SUNDRY NOTICES AND REPORTS ON WELLS (DO NOT USE THIS FORM FOR PROPOSALS TO DRILL OR TO DEEPEN OR PLUG BACK TO A DIFFERENT RESERVOIR. USE "APPLICATION FOR PERMIT" (FORM C-101) FOR SUCH PROPOSALS.) 1. Type of Well: Oil Well ☒ Gas Well ☐ Other ☐		WELL API NO. 30-025-53054 5. Indicate Type of Lease STATE ☐ FEE ☒ 6. State Oil & Gas Lease No.
2. Name of Operator EOG RESOURCES, INC.		7. Lease Name or Unit Agreement Name OSPREY 10 8. Well Number 102H
3. Address of Operator P.O. Box 2267 Midland, Texas 79702		9. OGRID Number 7377 10. Pool name or Wildcat 97369 - RED HILLS;BONE SPRING, EAST
4. Well Location Unit Letter N : 140' feet from the SOUTH line and 1574' feet from the WEST line Section 10 Township 25S Range 34E NMPM LEA County		
11. Elevation (Show whether DR, RKB, RT, GR, etc.) 3334' GR

EOG respectfully requests an amendment to our approved APD for this well to reflect the following changes:

OSPREY 10 521H (FKA 102H) API #: 30-025-53054

OSPREY 10 #521H
LEA County, New Mexico
Revised Wellbore

C-102 Submit Electronically Via OCD Permitting	State of New Mexico Energy, Minerals & Natural Resources Department OIL CONSERVATION DIVISION	Revised July 9, 2024	
		Submittal Type:	☐ Initial Submittal
			☒ Amended Report
Property Name and Well Number		OSPREY 10 521H

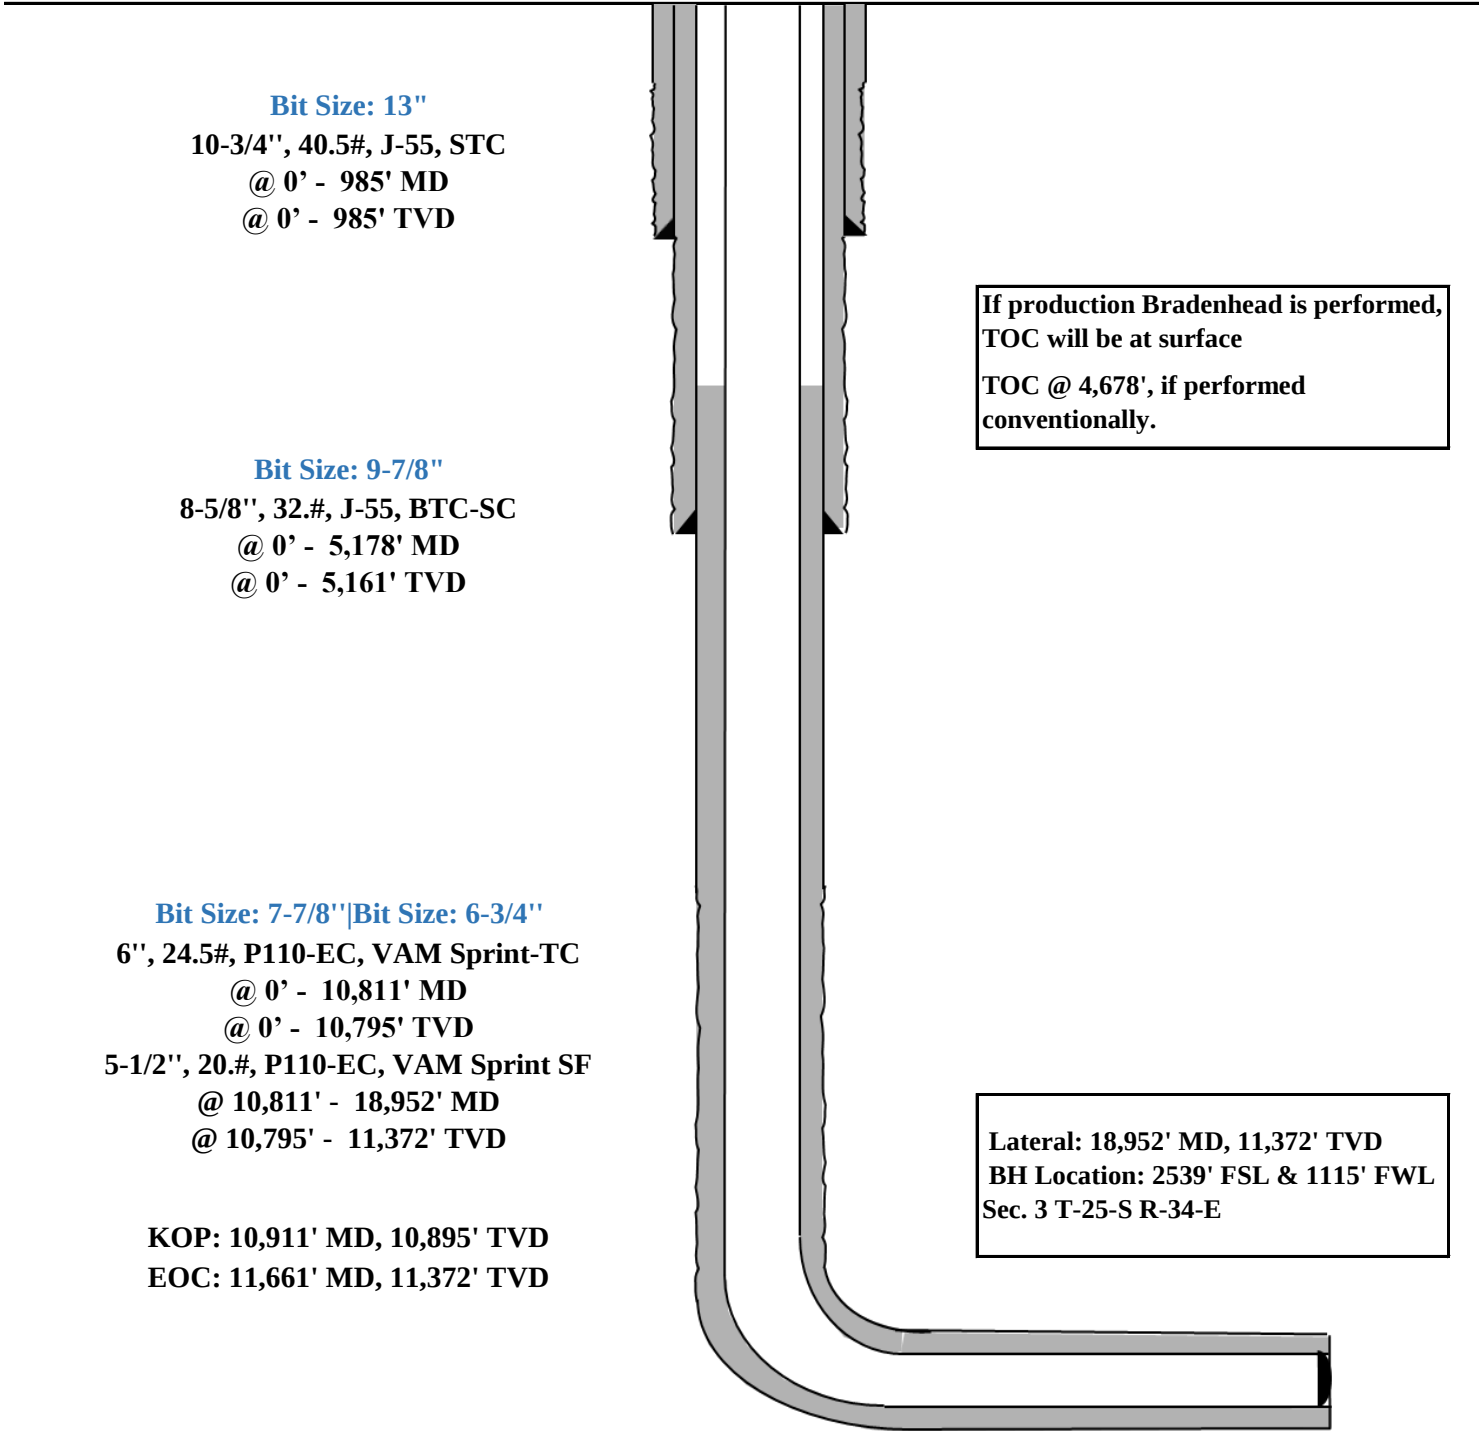
Change BHL from T-25-S, R-34-E, Sec 3, 2540' FSL, 1254' FWL, LEA Co., NM, to T-25-S, R-34-E, Sec 3, 2539' FSL, 1115' FWL, LEA Co., N.M.

UL or lot no.	Section	Township	Range	Lot Idn	Feet from the N/S	Feet from the E/W	Latitude	Longitude	County
L	3	25-S	34-E	-	2539' S	1115' W	N 32.1592663	W 103.4627114	LEA

**Break-test BOP & Offline Cementing:**

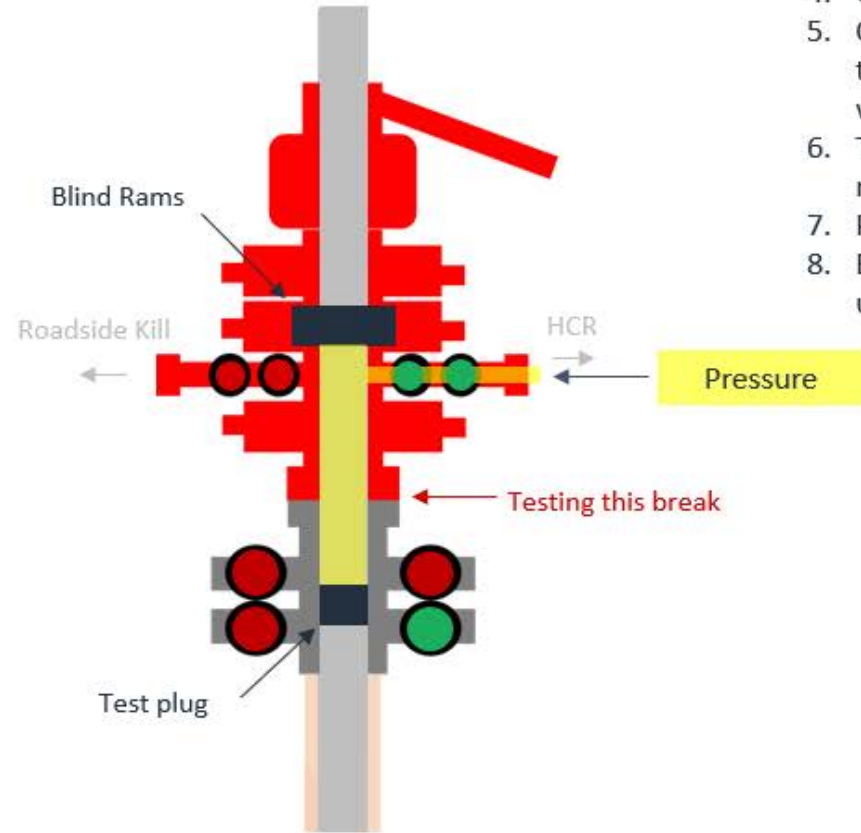
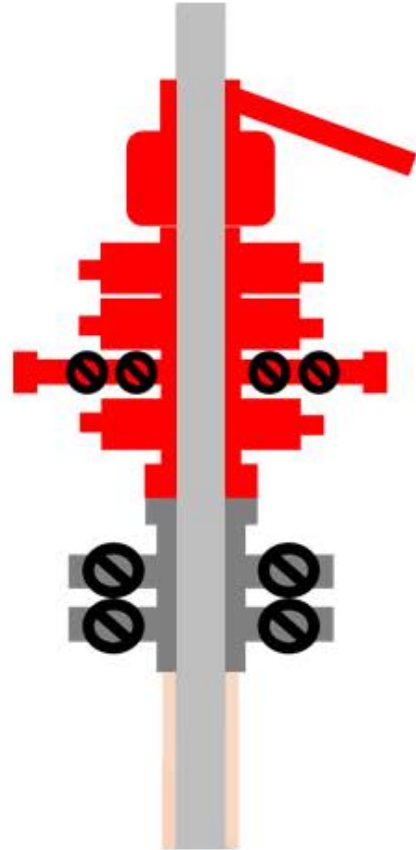
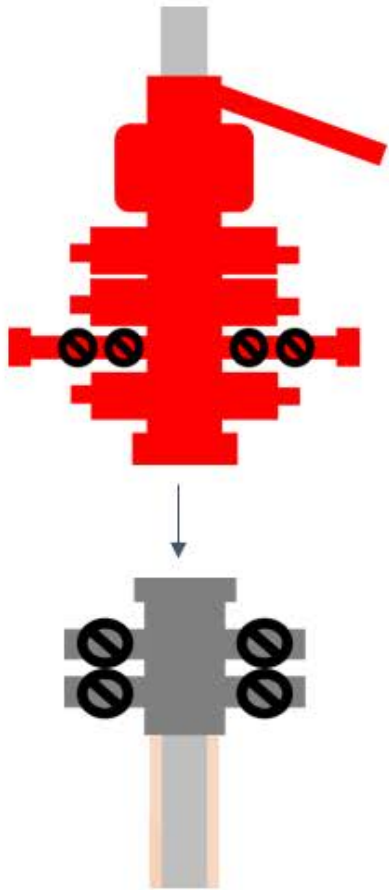
EOG Resources Inc. (EOG) respectfully requests a variance from the minimum standards for well control equipment testing of ECFR Title 43 Part 3172.6(b)(9)(iv) to allow a testing schedule of the blow out preventer (BOP) and blow out prevention equipment (BOPE) along with Batch Drilling & Offline cement operations to include the following:

- Full BOPE test at first installation on the pad.
- Full BOPE test every 30 days.
- This test will be conducted for 5M rated hole intervals only.
- Each rig requesting the break-test variance is capable of picking up the BOP without damaging components using winches, following API Standard 53, Well Control Equipment Systems for Drilling Wells (Fifth edition, December 2018, Annex C. Table C.4) which recognizes break testing as an acceptable practice.
